Part 573 Safety Recall Report

23V-700

Manufacturer Name : BMW of North America, LLC

RECALL 23V-XXX: STEERING WHEEL GROUND CONNECTION

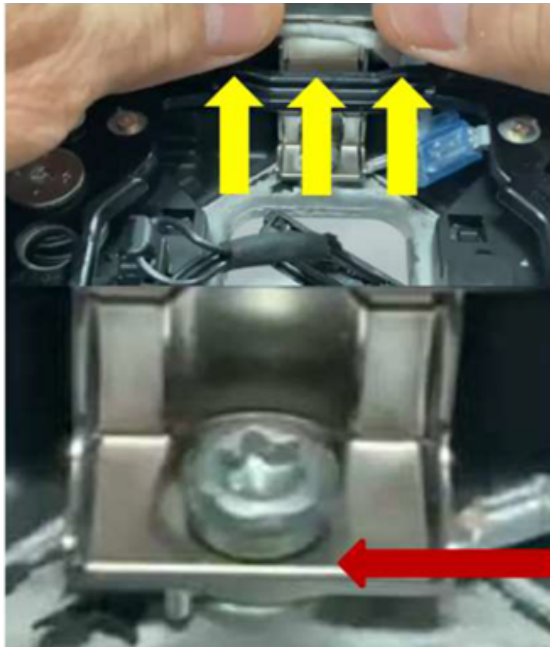
A ground wire might not be properly fastened in the steering wheel. This can cause a loose connection which indicates hands are ON the steering wheel even when being driven with hands-off.

2. Remove the steering wheel airbag following the repair instructions listed in ISTA/AIR 32 34 030 and check the ground connection.

3. If the ground connection screw is not in contact with the horn plate bracket upon visual inspection but is tight and at the correct torque spec (2.5 Nm +/- 5 Nm), the screw must be removed, and the threads need to be inspected for any burr formations.

Add two (1 mm) thick washers under the screw head, then tighten screw to (2.5 Nm +/- 5 Nm).

4. If the screw is already in full contact with the horn plate bracket and is tighten to (2.5 Nm + - 5 Nm), check the tightness of the connection as explained below.

Press the horn cover from the inside out to observe any possible movement of the horn pad bracket and the screw.

5. If there is no relative movement, use a 0.1 mm feeler gauge between the bottom of the screw head and the horn pad bracket.

Note: DO NOT check the cable lug of the ground strap for tightness.

Be careful when inserting the screw, because the cable lug is sensitive to force and tensile loads due to its geometry.
